## ORIGINATION FORM

### Proposed Revisions to a Standard Plans Index (Please provide all information — Incomplete forms will be returned)

Index Number: 455-154

Index Title: 54" Precast/Post-Tensioned CFRP & SS Concrete  
Cylinder Pile +**Summary of the changes:**

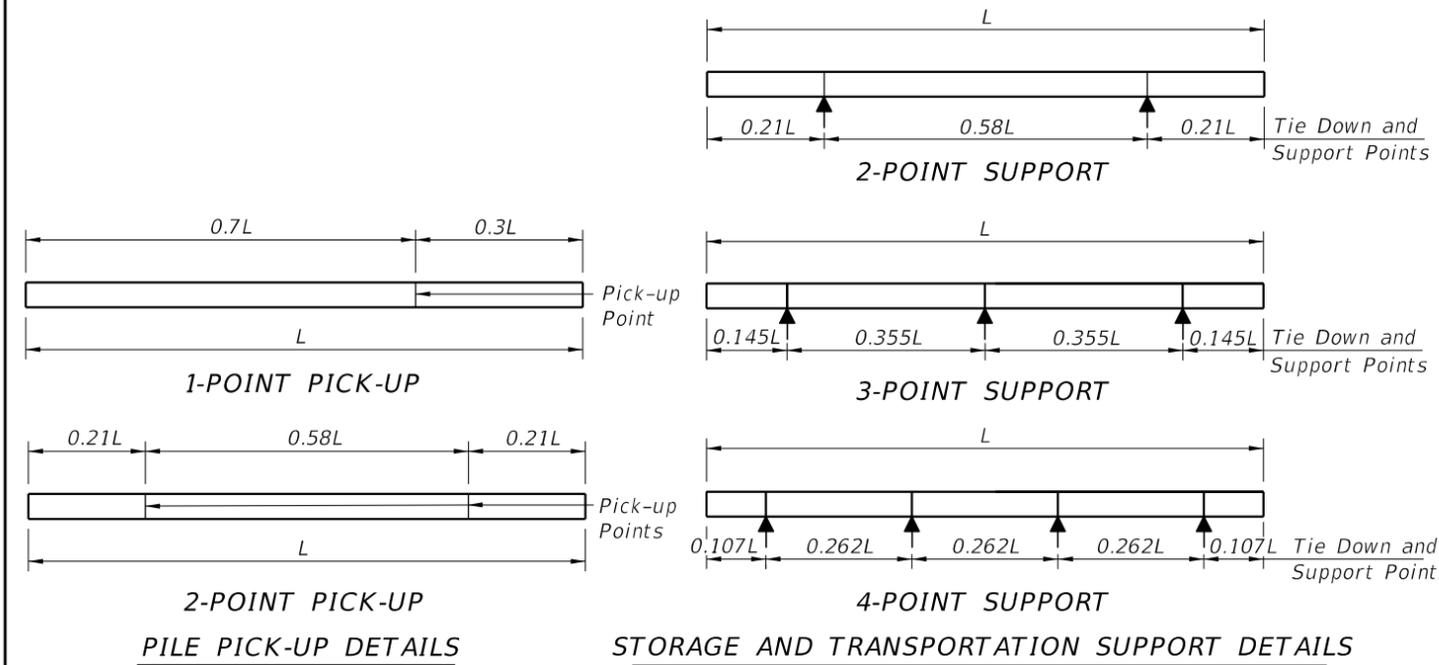
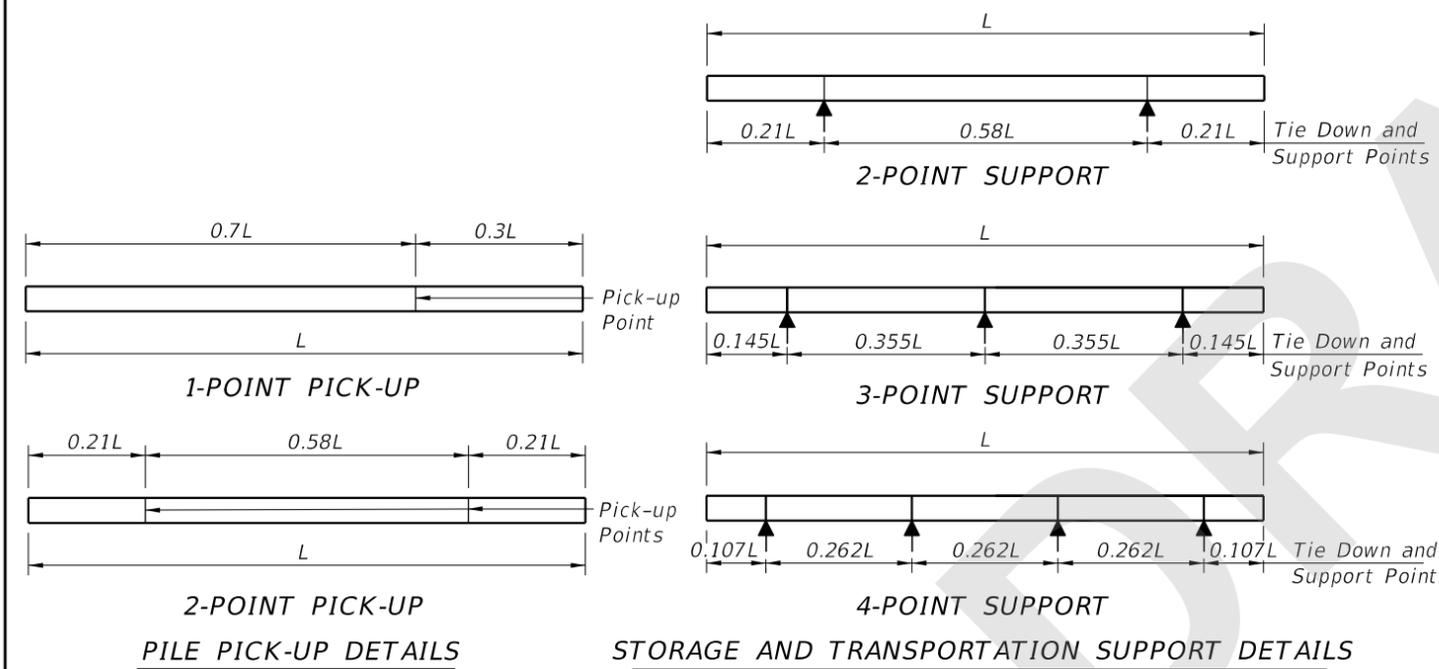
Change Silica Fume, metakaolin or ultra-fine flyash to Highly Reactive Pozzolans

Specification changed to fit silica fume, metakaolin and ultra-fine flyash under Highly Reactive Pozzolans

- Work this Index with the Pile Data Table in the Structures Plans.
- Concrete:
  - Piles: Class V (Special)
  - Splice: Class IV
  - ~~Silica Fume: See "GENERAL NOTES" in Structures Plans for locations where the use of silica fume, metakaolin or ultra-fine flyash is required for options using stainless steel strand and reinforcing.~~ **Highly Reactive Pozzolans**

1. Work this Index with the Pile Data Table in the Structures Plans.
2. Concrete:
  - A. Piles: Class V (Special)
  - B. Splice: Class IV
  - C. See "GENERAL NOTES" in Structures Plans for locations where the use of Highly Reactive Pozzolans is required for options using stainless steel strand and reinforcing.
